Aiken Intermediate – Bus Transportation Office Aiken County Public School District

October 6, 2026

Addendum No. 02

Drawing No.
A4.1

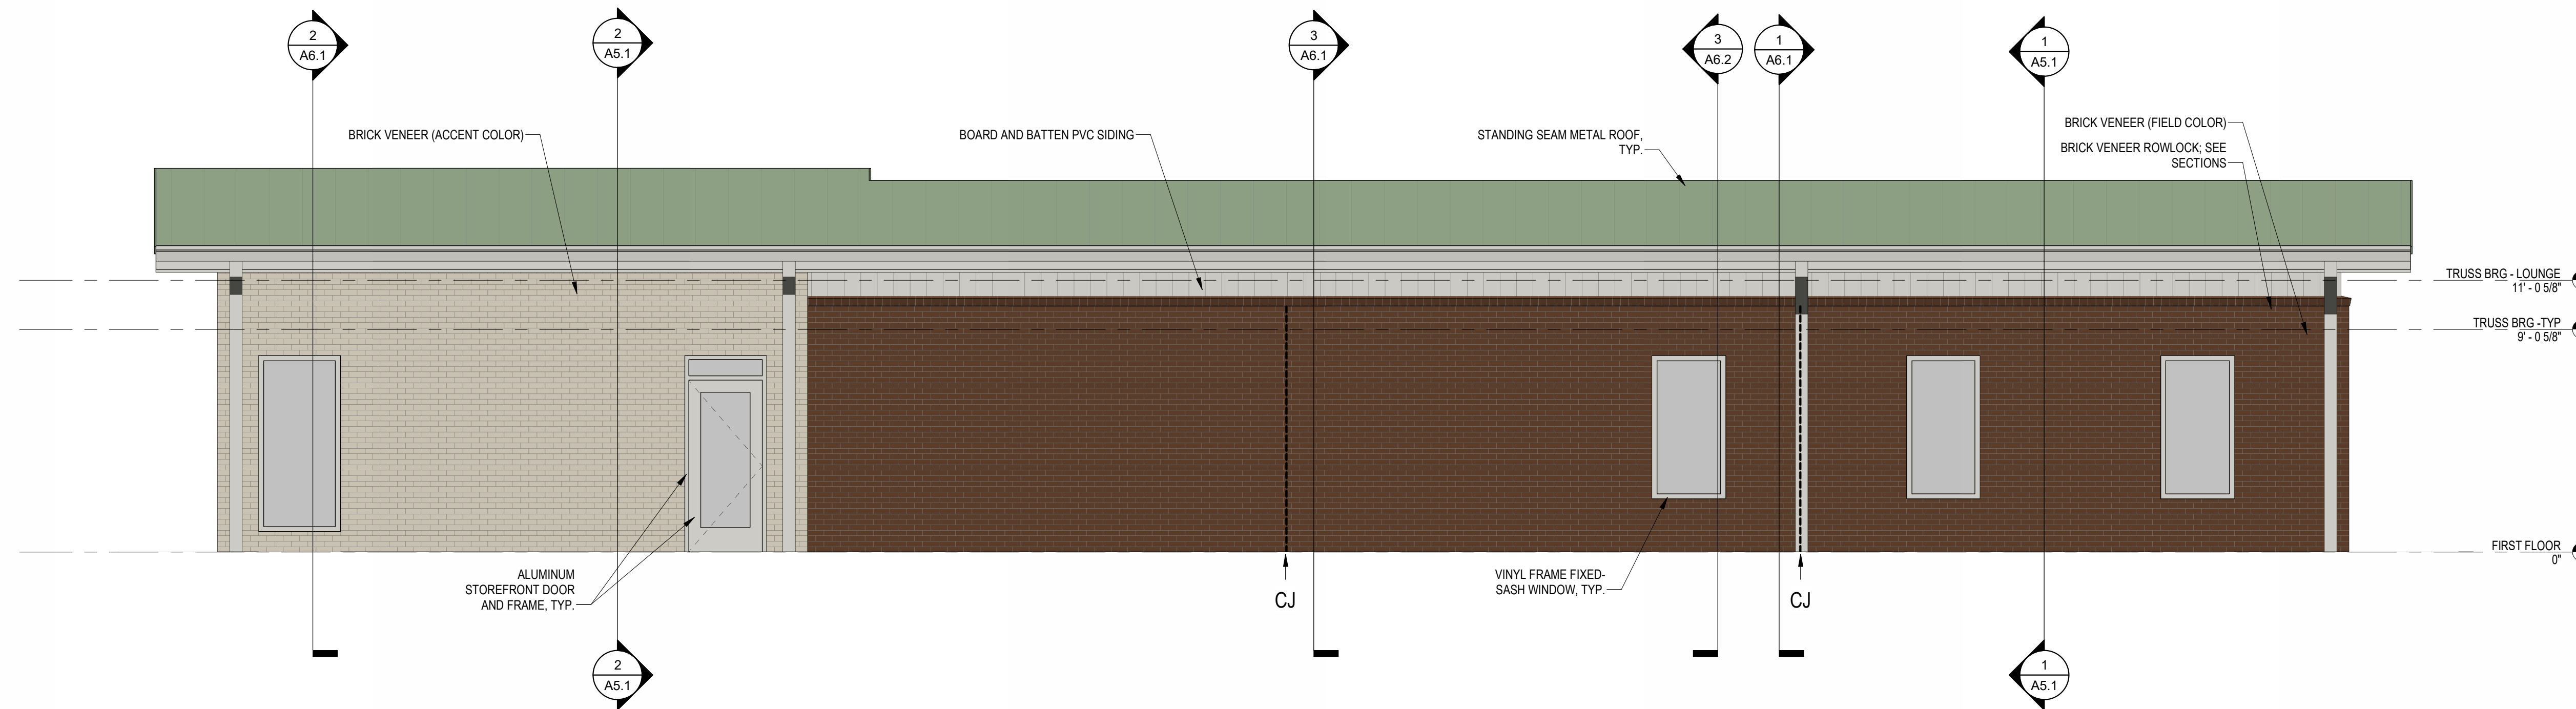
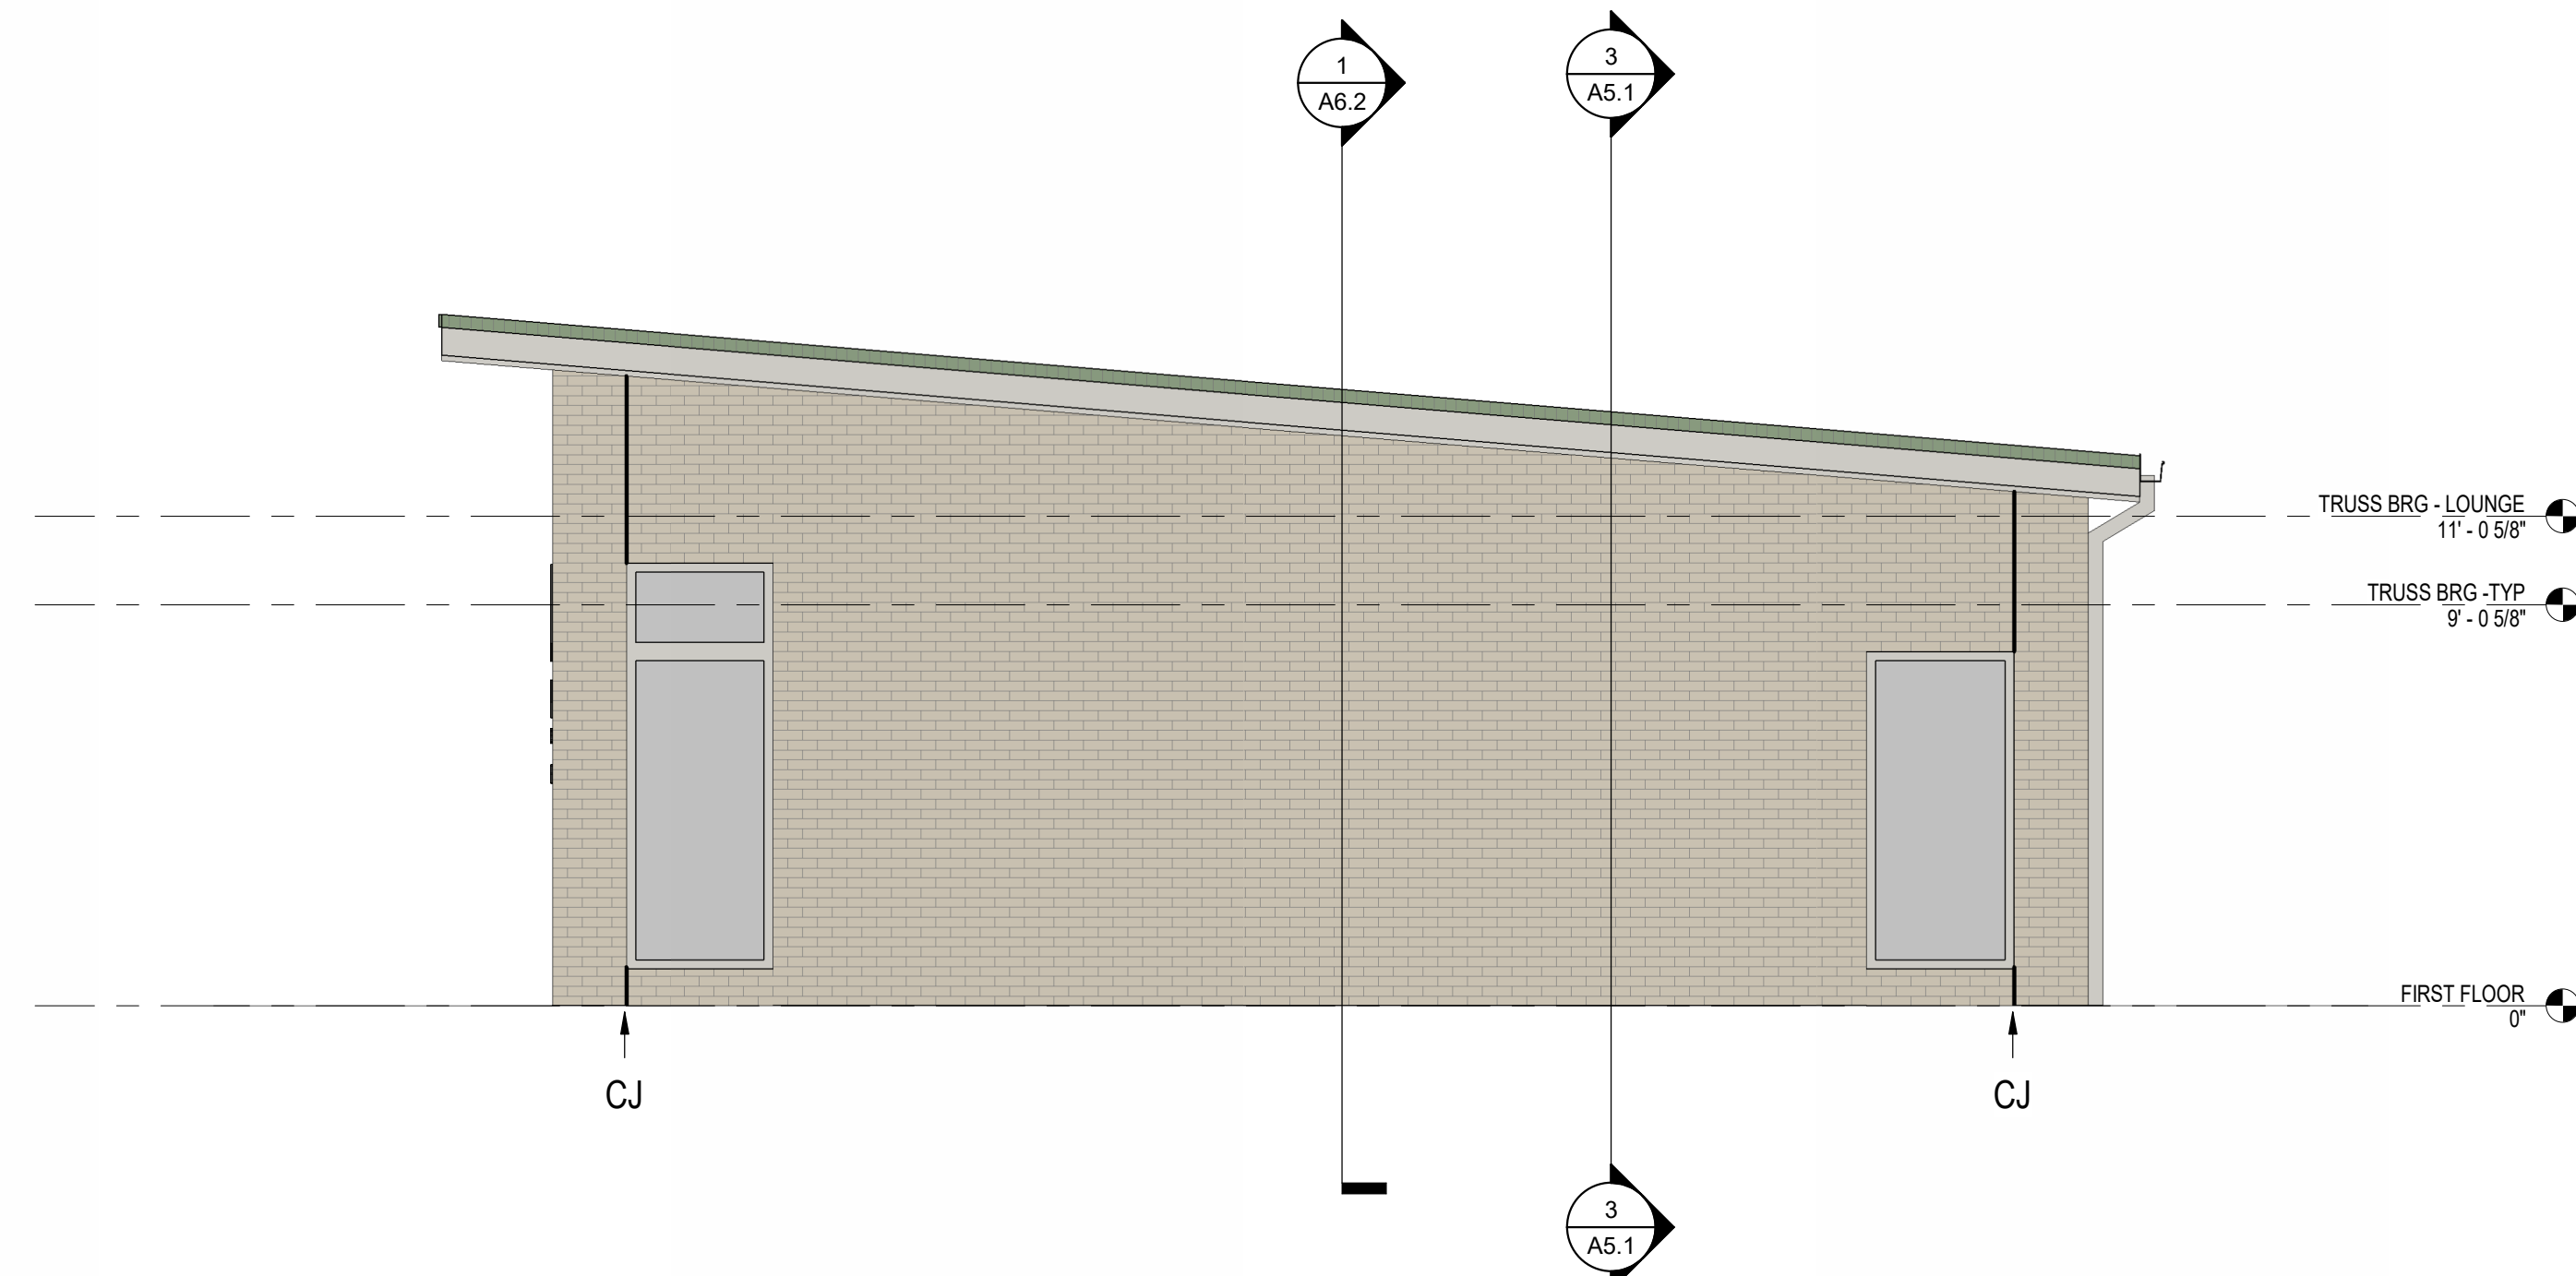
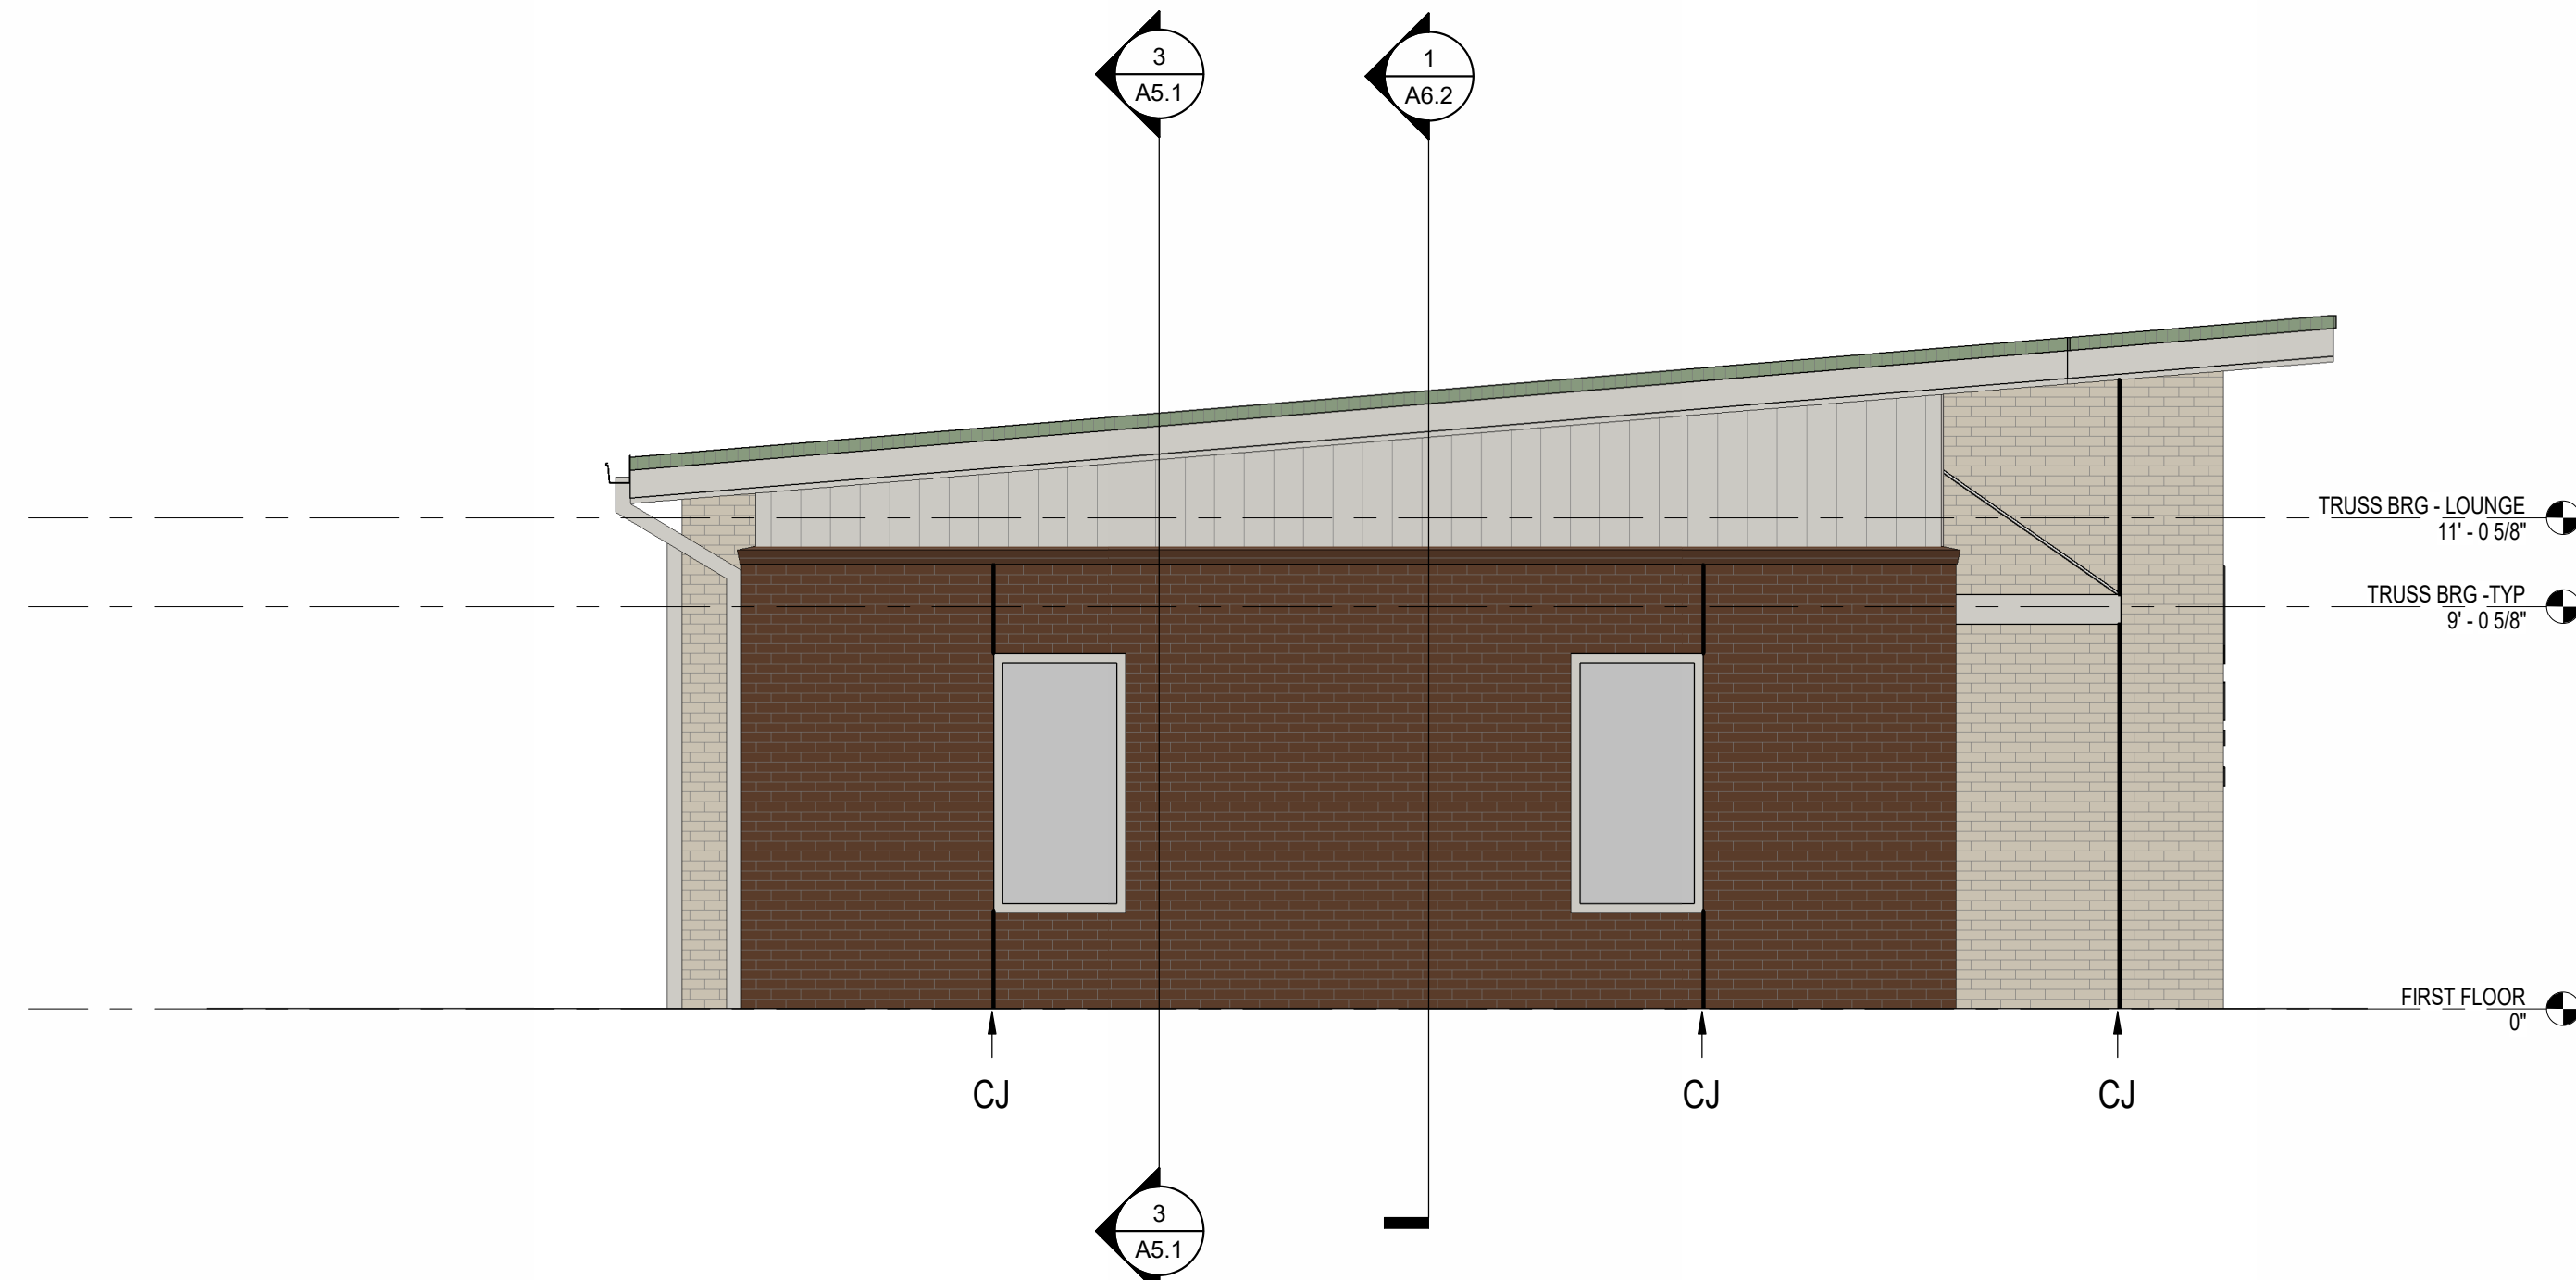
1. Drawing A4.1

- a. See revisions regarding exterior vinyl siding finishes.

1. The Ply Gem vertical siding specified doesn't appear to be available in the color specified. The color options affect the price per carton. Is there another color that may be acceptable?

Yes, please provide this material in the color, "Sand". See the revised A4.1 sheet attached.
